Quality Control Check Report      Stage: Before Casting Slab (Villas)

Block No	282	Slab No.	02	Sl. No.	33502
Company	VOC LLEP	Project	VOC	Phase	—
Prepared by	A. RATESH	Sign	<i>[Signature]</i>	Date	02/04/19
Project Manager	A. SURESH	Sign	<i>[Signature]</i>	Date	02/04/19
Previous stage report no.		33399	Report filed and signed by PM?	<input checked="" type="checkbox"/> Yes <input type="checkbox"/> No	
Checked By MD on		MD Sign		For filling	<input type="checkbox"/> Yes <input type="checkbox"/> No

FIRST FLOOR SLAB

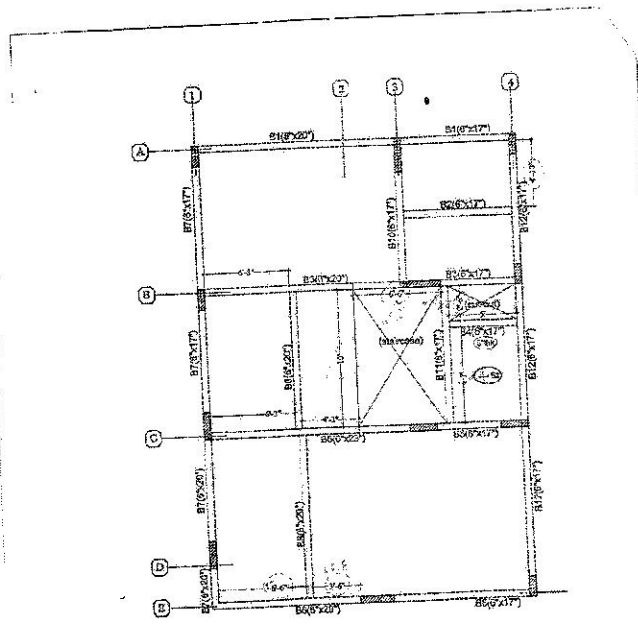
Slab Dimensions Check Plan enclosed?	<input checked="" type="checkbox"/> Yes <input type="checkbox"/> No				
Staircase - mid landing 1	<input checked="" type="checkbox"/> Yes	Specified ht:	4'9"	Actual ht:	4'9"
				Within tolerance of 1/2"?	<input type="checkbox"/> Yes <input checked="" type="checkbox"/> No
Staircase - mid landing 2	<input type="checkbox"/> No	Specified ht:	—	Actual ht:	—
				Within tolerance of 1/2"?	<input type="checkbox"/> Yes <input checked="" type="checkbox"/> No
Staircase width	<input checked="" type="checkbox"/> Yes	Specified wd:	3'	Actual wd:	3'
				Within tolerance of 1/2"?	<input checked="" type="checkbox"/> Yes <input type="checkbox"/> No
Staircase slab thickness	<input checked="" type="checkbox"/> Yes	Specified:	5"	Actual:	4"
				Within tolerance of 1/4"?	<input type="checkbox"/> Yes <input checked="" type="checkbox"/> No

Remarks:	
	1. More numbers of Honey Combs for slab & staircase
	2. Staircase waist slab instead of 5" they casted 4"
	3. Slab & Beam Rod Bending work was very poor

4. Shuttering was very poor & not leveled
	5. Engineers <del>start</del> self check was not done
	6. At the time of checking concern engineer was leave
